Proposed Remedy for Comments Regarding V_{oc} Max Limit During Detection of Classifying Only PDs

Andy Gardner and Michael Paul

Table 104-3—PSE PI detection state electrical output requirements

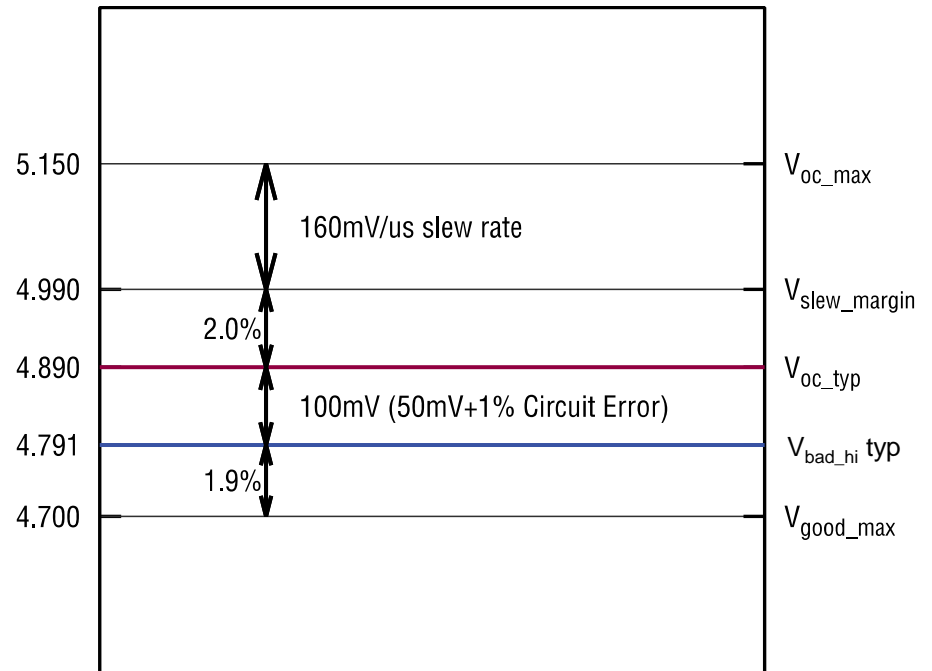
Parameters changed for D3.1

- PSEs are now required to limit open-circuit voltage between 4.75V and 5.15V during detection
- Minimum input capacitance of a classifying PD that presents a bad-high signature is not constrained, and this can result in fast slew rates at the PSE when approaching V_{OC} during detection
- These requirements are forcing the detection over-voltage clamp circuit to be both **fast** and **accurate**

Design Example with Proposed V_{OC} max Threshold

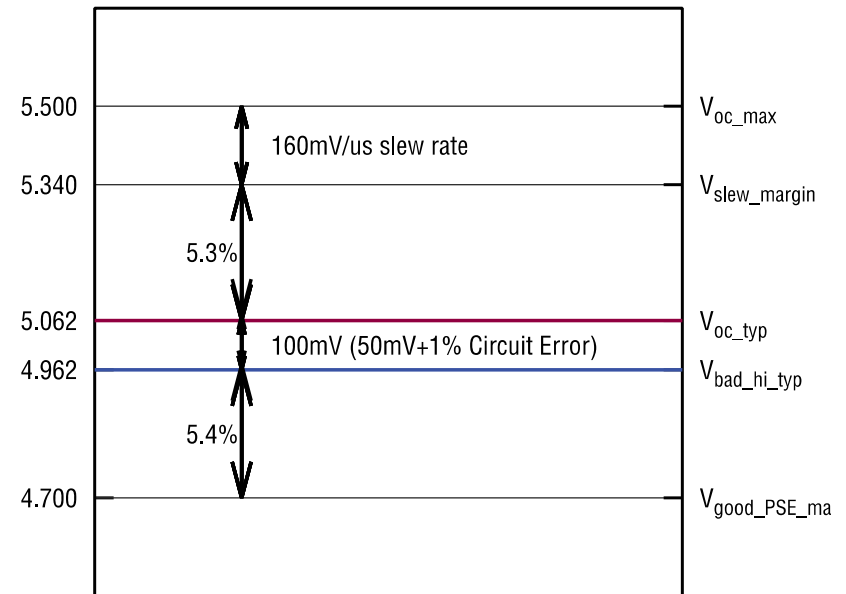
- Relax V_{OC} max to what it was in draft 3.0 (5.5V)
- Relaxation of V_{OC} max to 5.5V will potentially interfere with V_{on} for the 12V unregulated classes, but...
- The 12V unregulated classes target automotive applications and do not require classification
 - Add new footnote to Table 104-1 stating
“ePDs that require Classification for Classes 0 and 1 are not supported.”
